### **Manor House Farm, Troutsdale**

With my apologies for taking so long to respond and as a further follow up to your recent letter about the proposed reconstruction and conversion of the barn at manor House Farm, I enclose a set of revised drawings which I hope answer the queries that you raised and I also reaffirm some previous answers:

Proposed Re-construction & Alterations to Existing Barn  
 At Manor House Farm, Troutsdale, Scarborough  
 For: Mr. J Guthrie

Stone Barn - ground floor layout as proposed

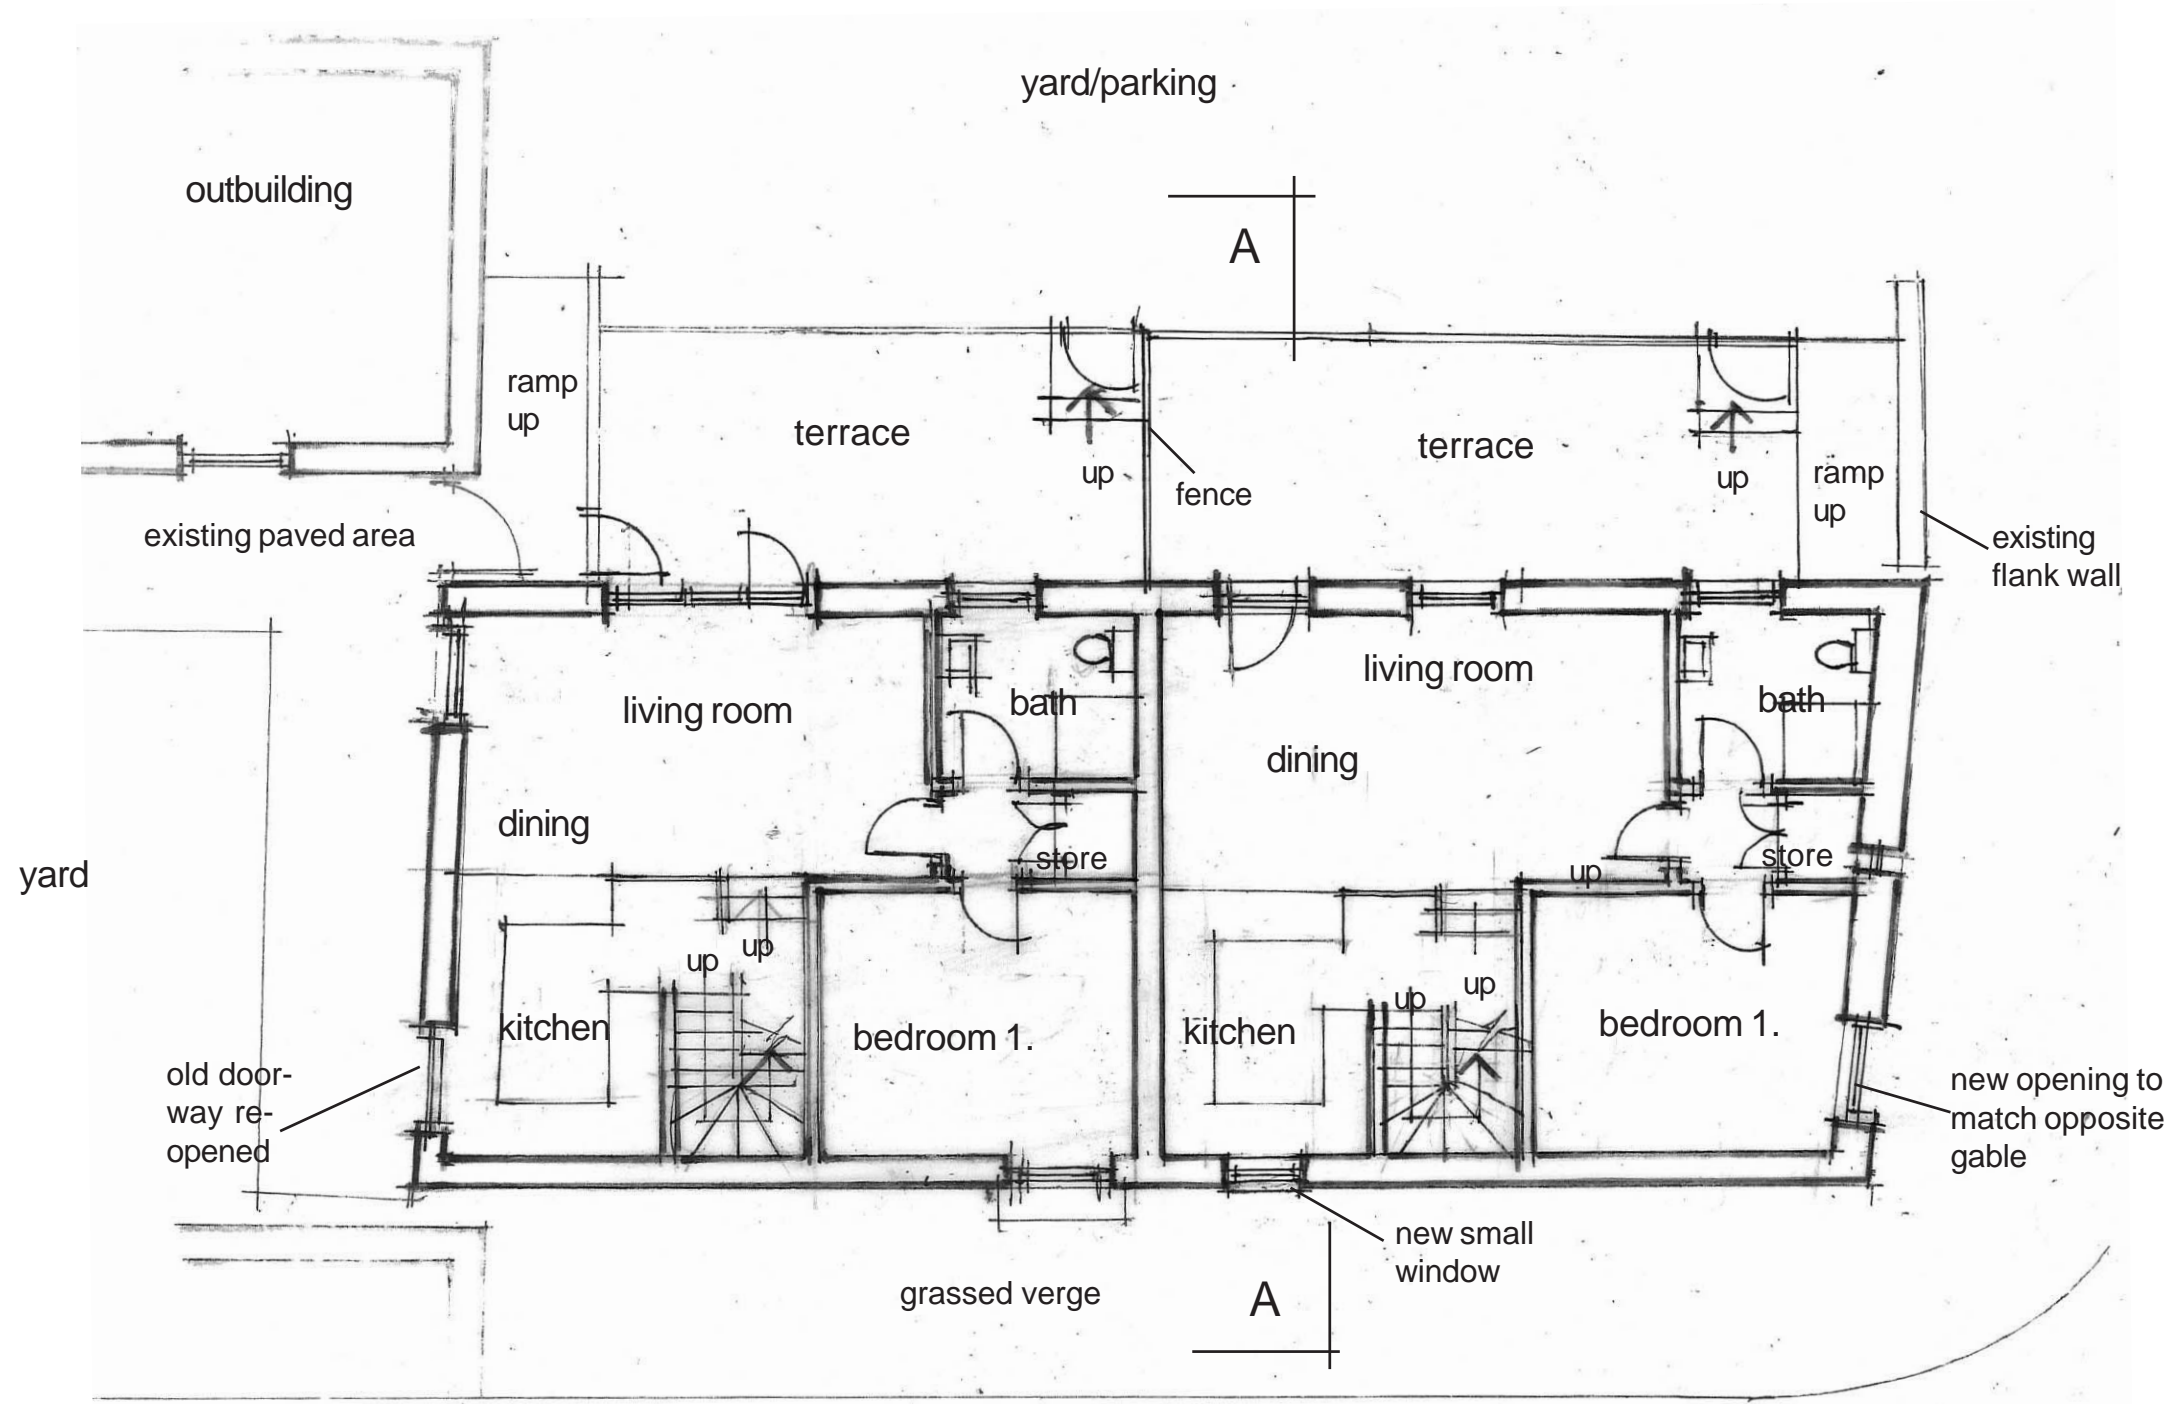
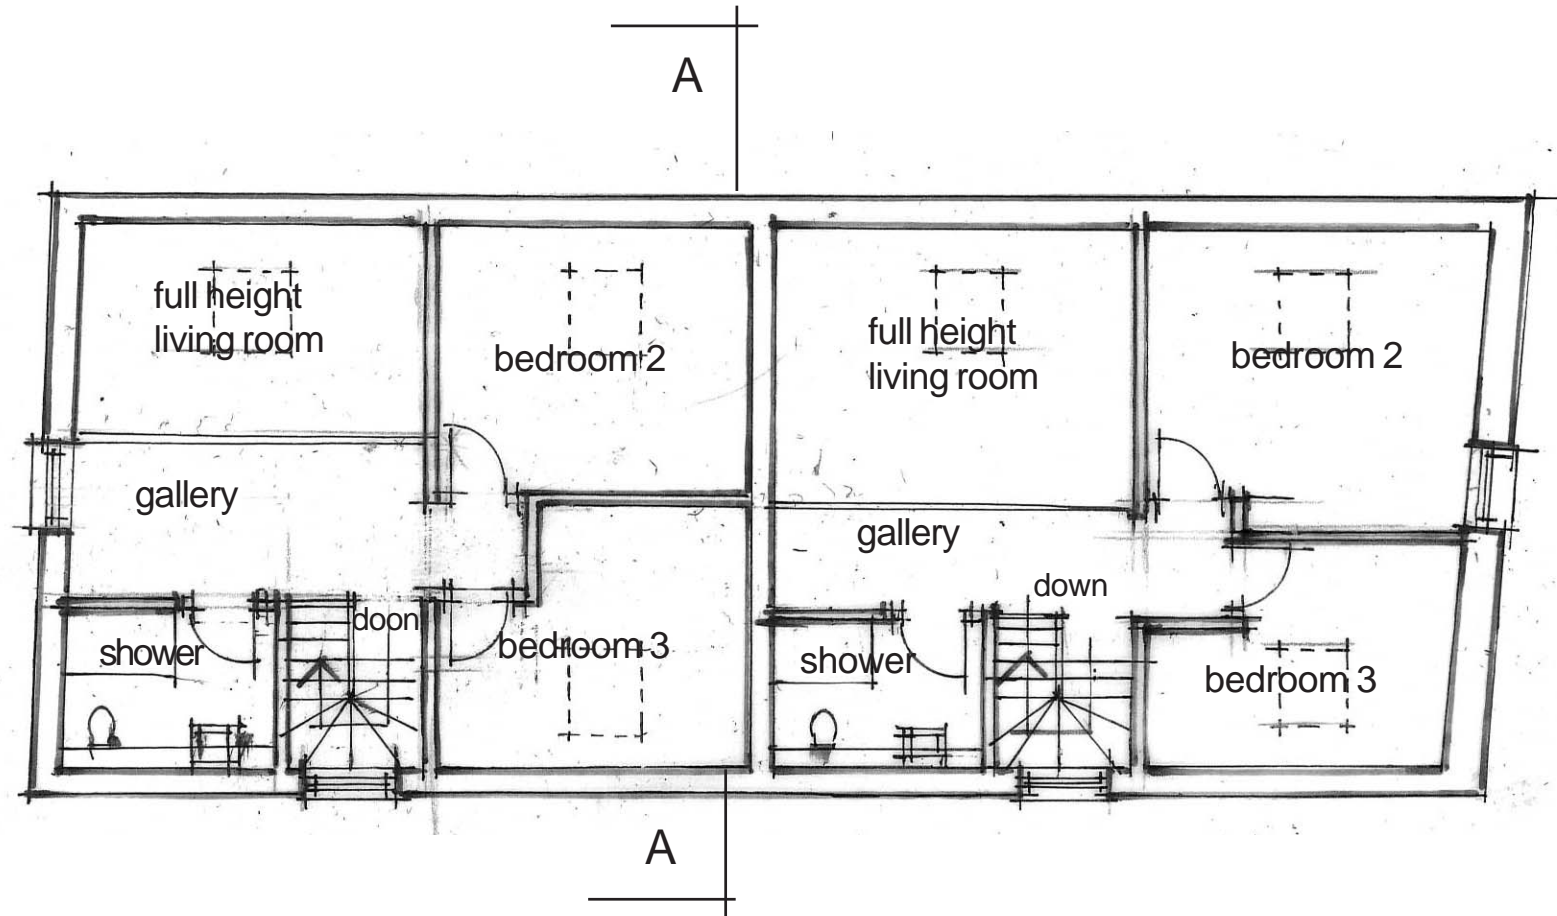
2. Creation of a new doorway – The internal layout has been revised to reinstate an old blocked up doorway and to introduce a matching one on the opposite gable as you suggested. We have removed the second doorway on the west elevation but would like to introduce a small window here to give some light into a dark corner – I do not think that this is out of place.

Rev A - various changes July '23  
 Rev B - door/window revisions Aug. '23

Stone Barn - Elevations as Proposed 1.

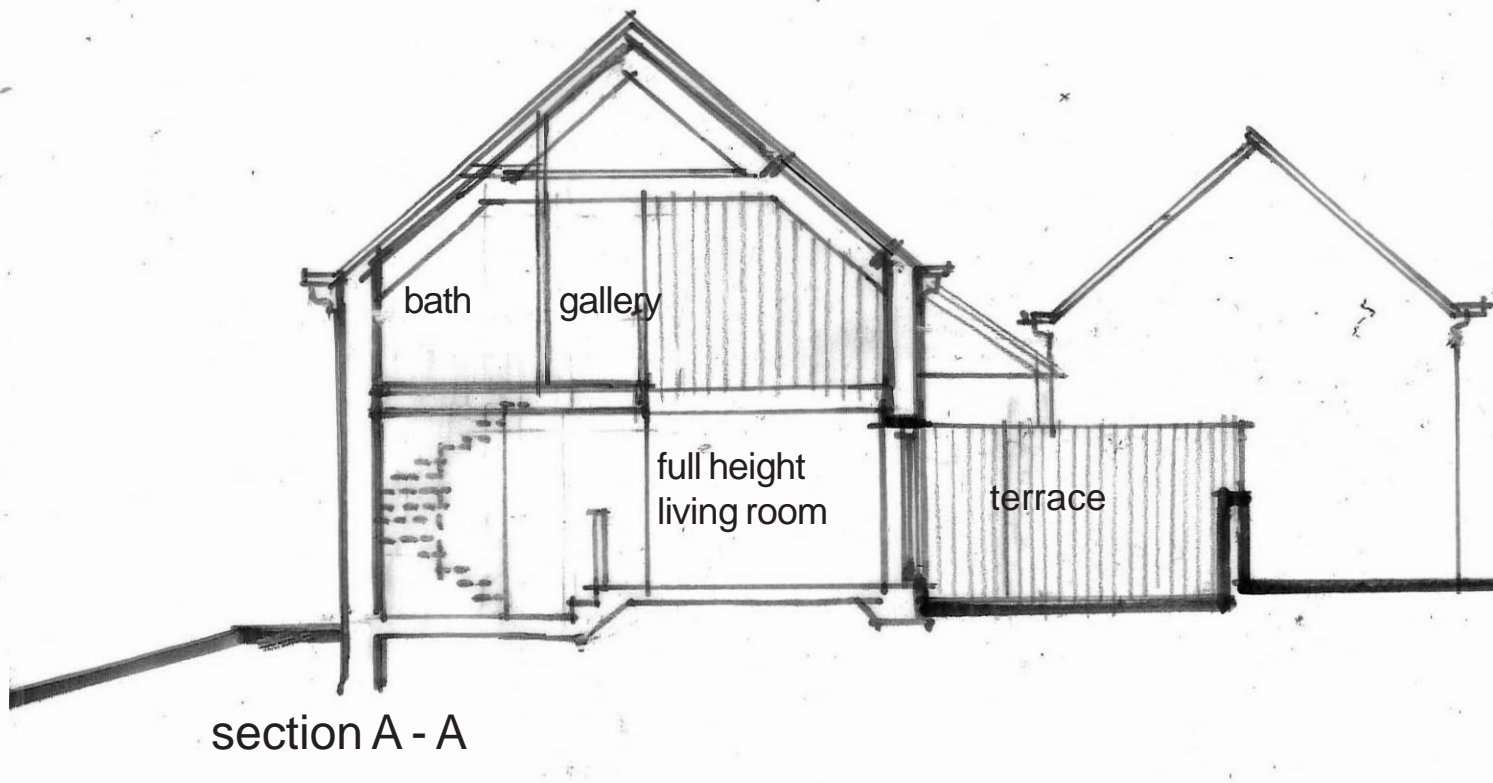
3. Plans not matching? I think that everything matches on the revised drawings.
4. Omitting the lantern lights and substituting rooflights – not so good but perfectly possible. The east elevation has been changed to show 4 conservation style rooflights (by the Rooflight Company) but we would still prefer to reintroduce some larger areas of glazing as you appeared to agree with in a previous letter as follows *“In one paragraph you say that, in your opinion, the patent glazed area should be omitted whereas, in the previous paragraph you say that you would support an area “being fully glazed to create more light into the upper floor” - we would obviously like to add more glazing as we had previously indicated and these two comments appear to be contradictory*  
Can you clarify this point please?

Rev A - door/window revisions Aug. '23

Stone Barn - Elevations as proposed 2

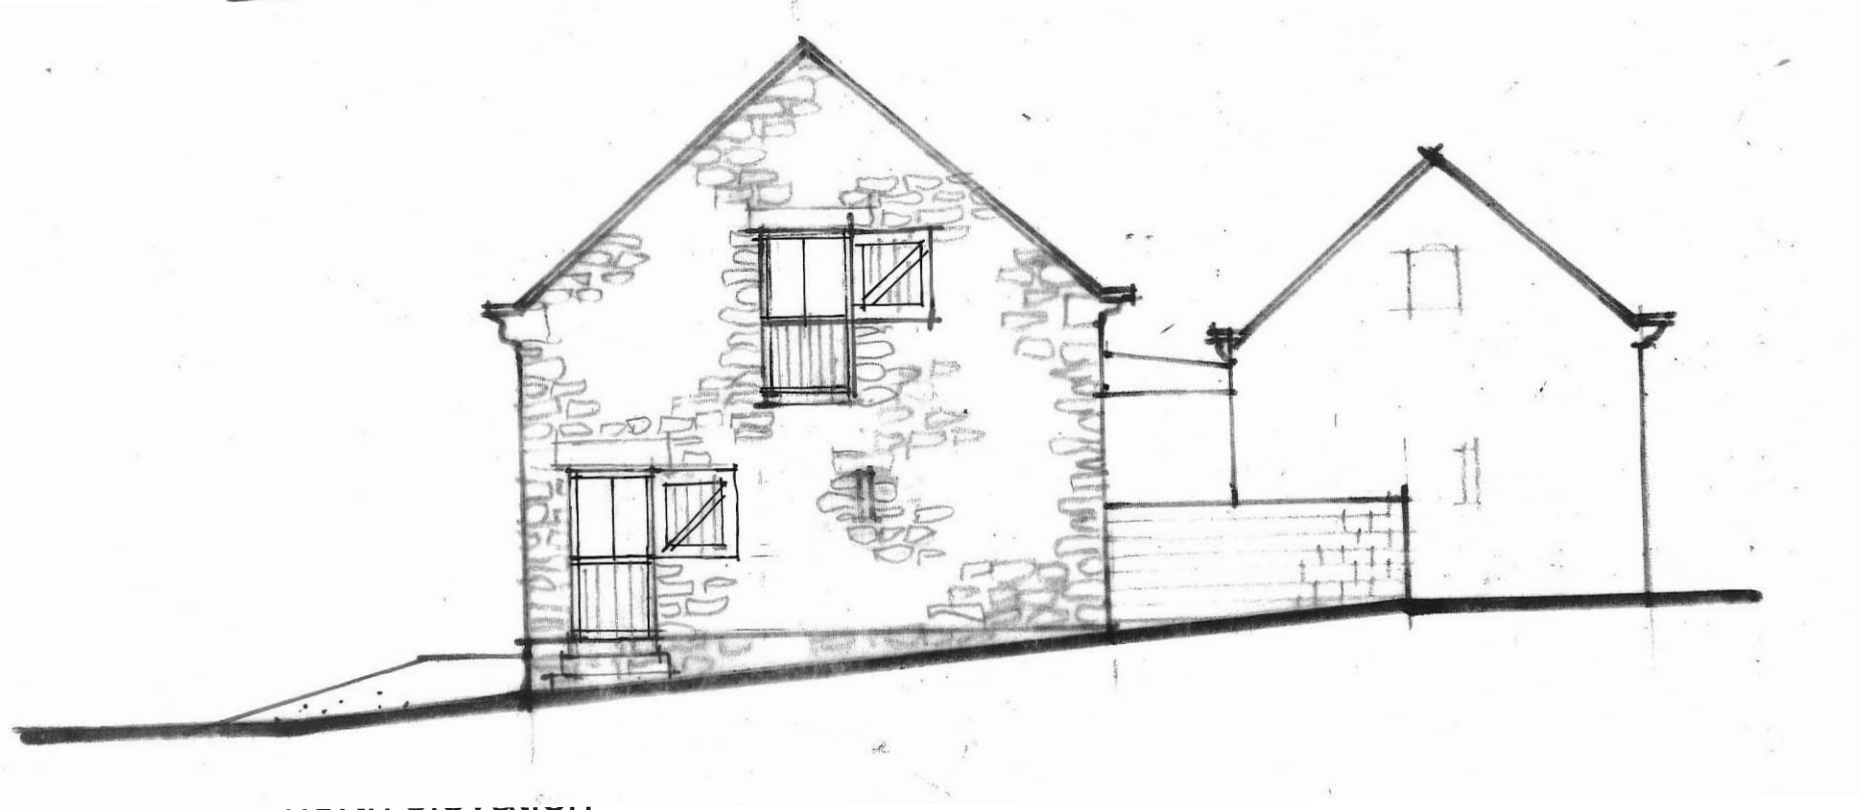
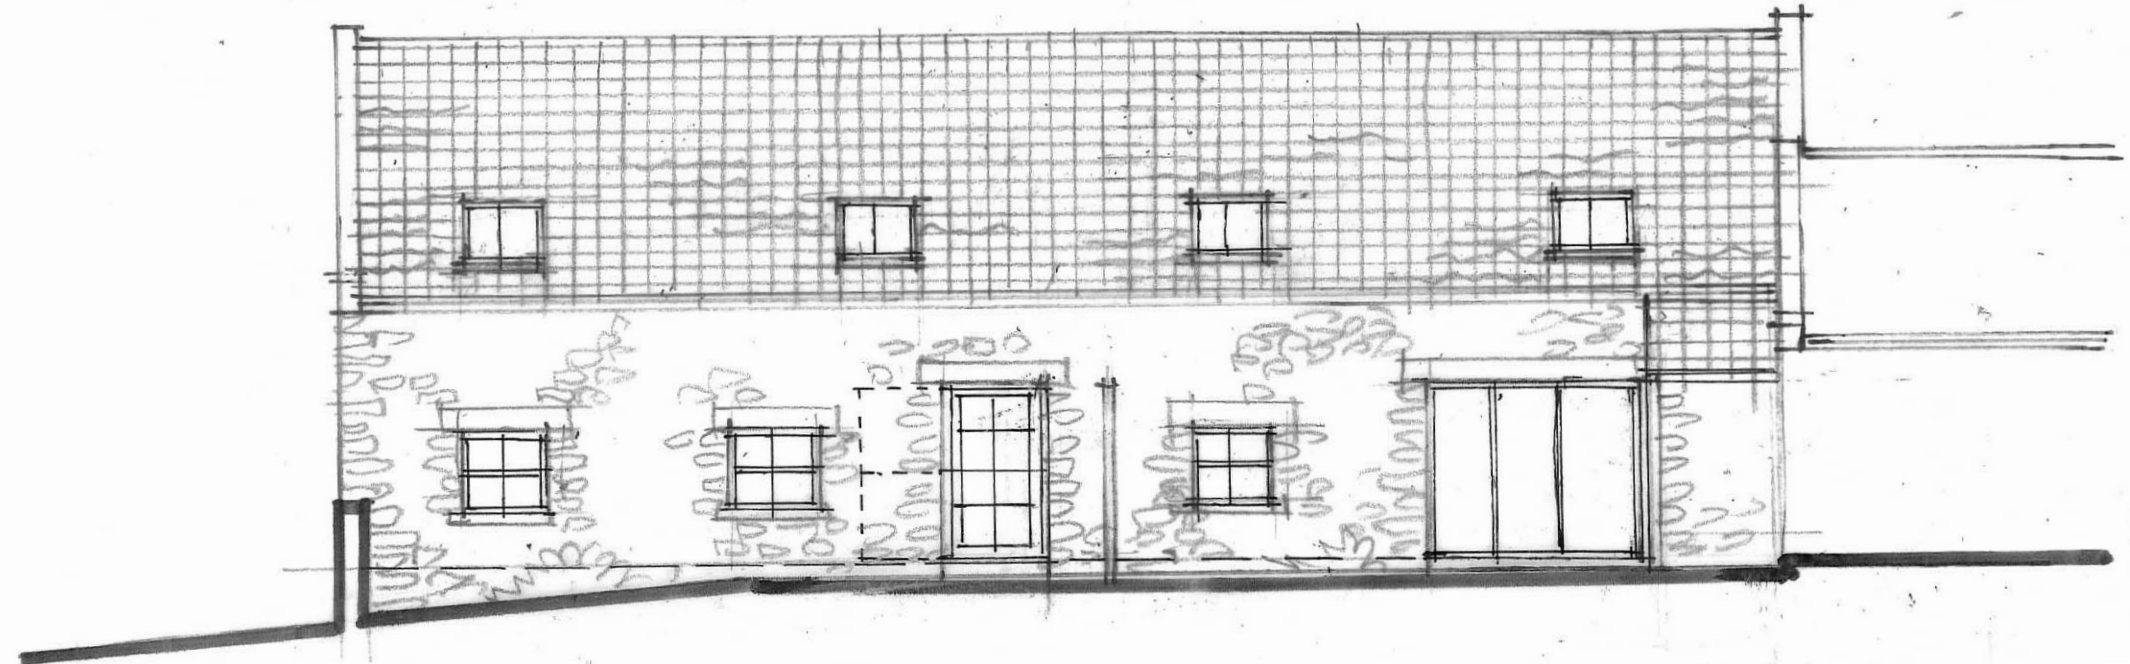
5. Only one cart door? We have adapted the plans to show a majority of existing openings with only one “cart opening” introduced. We still believe that it would not have been in the least unusual for a farm building of this size to have more than one larger opening. In fact a complete “arcaded” frontage with a series of cart openings would not have been

unusual. I would still hope that you would reconsider the introduction of at least one more cart size opening. I think that the fact that this elevation had been concealed behind other long gone farm buildings makes any significance to its current appearance fairly unimportant in the overall farm complex.

Rev A - door/window revisions Aug. '23
